SERVICE NOTE

GAME/ASSEMBLY

AFFECTED: G-80 CPU Bd.

EFFECT: G-80 Power Supply

G-80 Power Supply PC Assembly

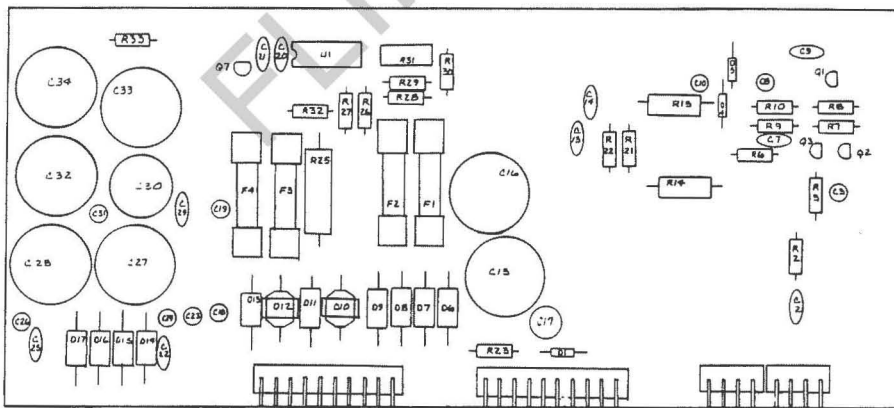
It has been noted that an "in-house" modification of the G-80 Power Supply (P/N 800-0191) may not have been accomplished on all units in the field; the result of which distributes ground current return to an additional connector pin. We recommend that you verify and/or perform the following simple procedure. A list of games which utilize this power supply is below:

1. With the rear electronics compartment door open, remove the two phillips screws securing the power supply cover and set these and the cover aside.
2. Referring to the illustration below, inspect P4 pin-4 to see if this pin has been tied to ground, either by a "solder-bridge" or jumper-wire to pin-6 of the same plug.
3. In the advent your unit has not been modified, simply expose the "land" immediately adjacent to P4 pin-4, and solder a connection between the pin and the top of the PC board (P/N 800-0170); or if you prefer, simply solder a wire (14 AWG minimum) between pin-4 and pin-6 of P4. This completes the modification.

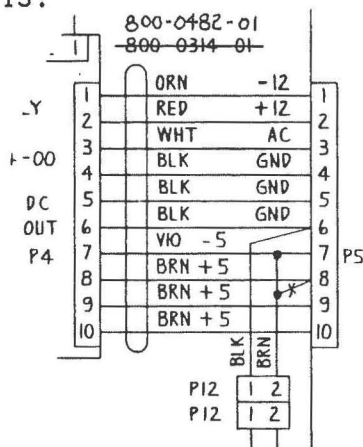
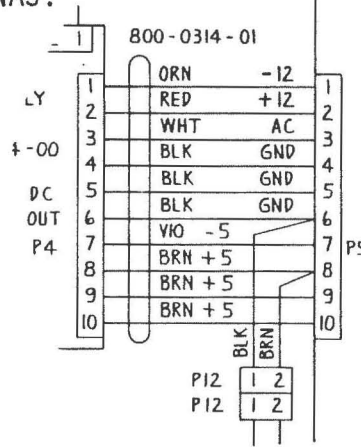
In the advent that you own a G-80 Power Supply - driven SEGA video game (refer to the list below), equipped with lighted coin mech.s, we recommend that you perform the following simple modification (that is designed to relieve the +5VDC supply of the load from the coin mech. lights):

1. Facing the open game electronics door, identify the power supply input connector (P5) at the rear left-hand side of the G-80 card cage.
2. Remove the connector, and with the connector windows facing you (pin-1, orange wire UP), identify the brown wire on pin-8 (coming from P12), and cut it off as near the connector as possible.

3. Now identify the violet wire on pin-7 of P5. Allowing an inch and a half to two inches back from the connector, cut the violet wire and strip 3/8" to 1/2" of insulation from the ends of all three wires (the two violet wire-ends and the single brown wire-end).

4. Twisting all three wires together, secure the connection with an insulated "blind-crimp" or wirenut.
5. Plug connector P5 back into the card cage ("windows" facing you), and the modification is complete. Correct the Cabinet Wiring Diagram as shown in the illustration, and change the Power Harness part number both on the Wiring Diagram and on the Top Assembly parts list (as shown here);

IS:

WAS:

ASS'Y VIC REPLACEMENT BOARD

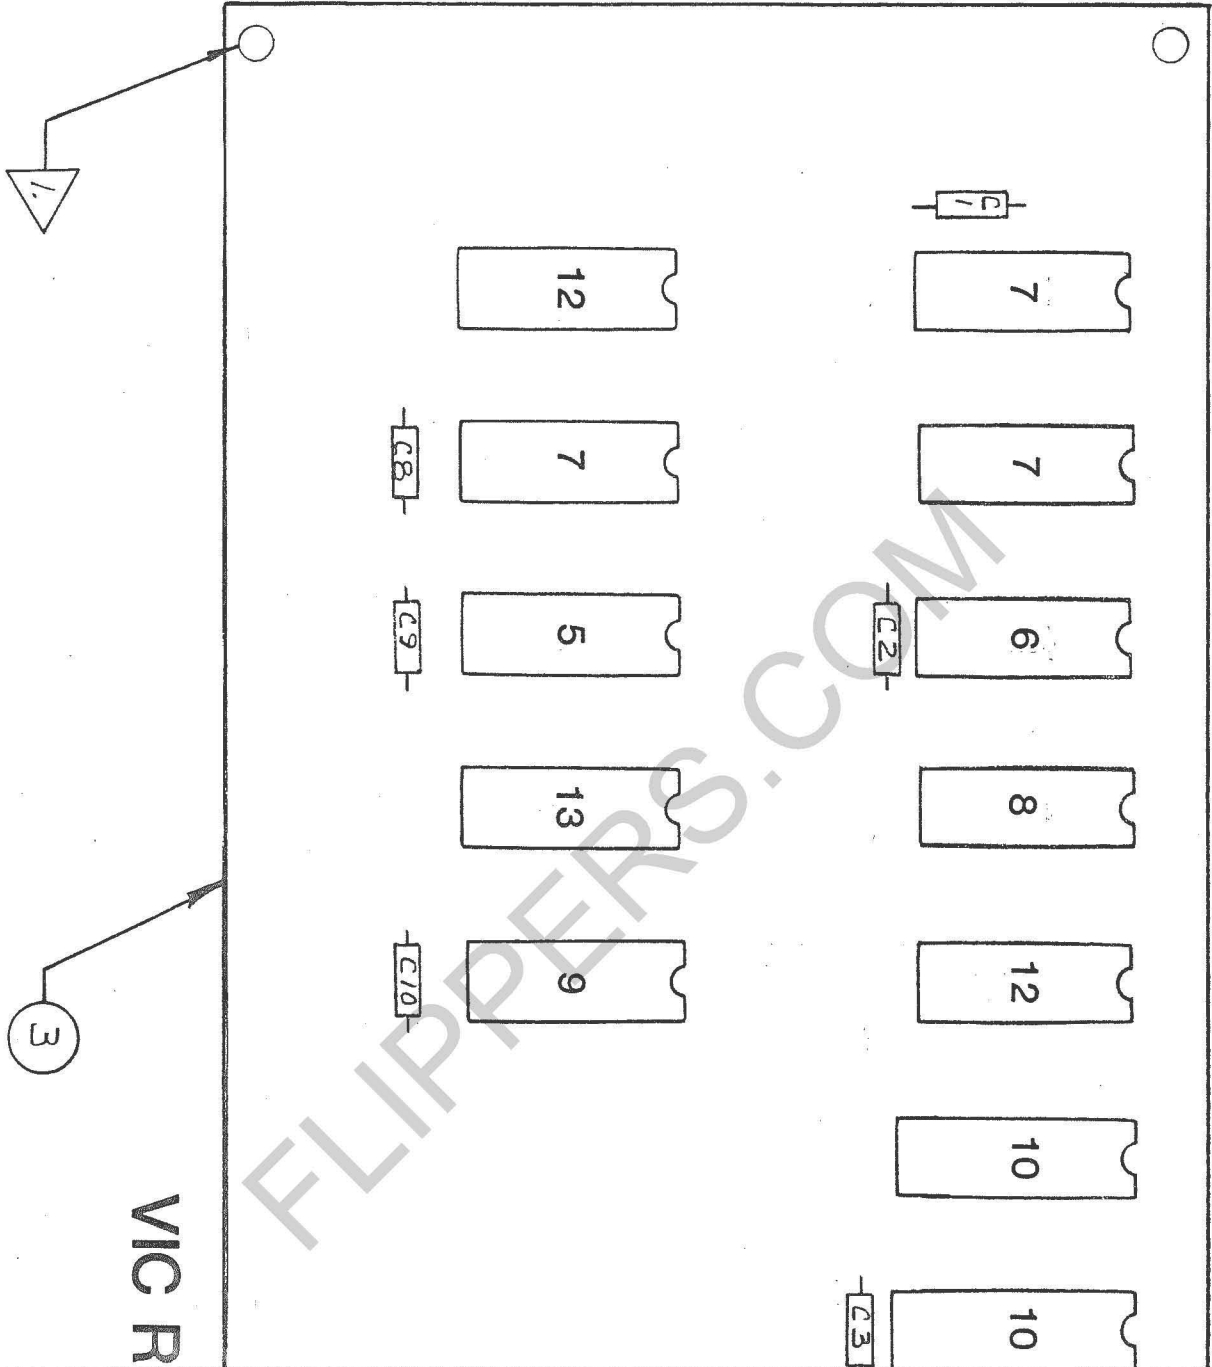
In some G-80 games (e.g. Astro Blaster) a VIC replacement board (pt.# 800-0212) may be used in place of the VIC chip. This board is located on the G-80 video board. Schematic and parts list for the VIC replacement board are enclosed.

On those video boards using the VIC replacement board, there are a few changes that have been made to the video board. Video boards using a VIC chip are slightly different.

1. 6 330 ohm resistors are added to the lines entering pins 5,6,7,10,11, & 12 of U24.
2. The 74LS74 IC at position U45 is replaced with a 74S74 IC. ✓
3. The 74LS175 IC's at positions U42 and U43 are replaced with 74S175 IC's. ✓
4. The 74LS163 IC at position U53 is replaced with a 74S163 IC. ✓
5. The 220pf 16V capacitor at position C10 is removed.
6. To simplify future troubleshooting, wherever an IC is replaced add a socket.

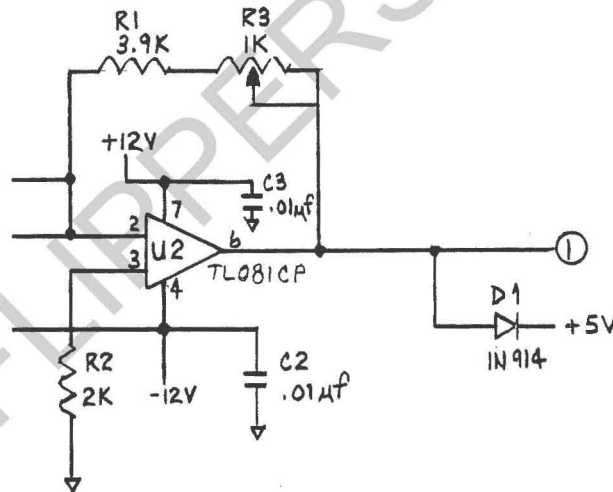
An occasional "glitch" problem in Color X-Y Monitor games has been traced to the X-Y Timing Board (P/N 800-0161). If you are experiencing this problem, please verify that the following modifications have been incorporated on your X-Y Timing Board. All factory STAR TREK™ boards are up to date, and as such these modifications apply only to TAC/SCAN™, ZEKTOR™, ELIMINATOR™, and SPACE FURY™.

1. Ensure that U2 and U3 are TL081CP (P/N 313-0037) IC's.
2. Ensure that the two 100pf 50V capacitors (C32 and C33) have been removed. These were located on the solder-side of the board, one connected between pin-2 and pin-6 of U2, and the other between pin-2 and pin6 of U3. Correct sheet 5 of the schematic for the X-Y Timing Board to reflect the following:

In Zone 4-C;

In Zone 4-B;
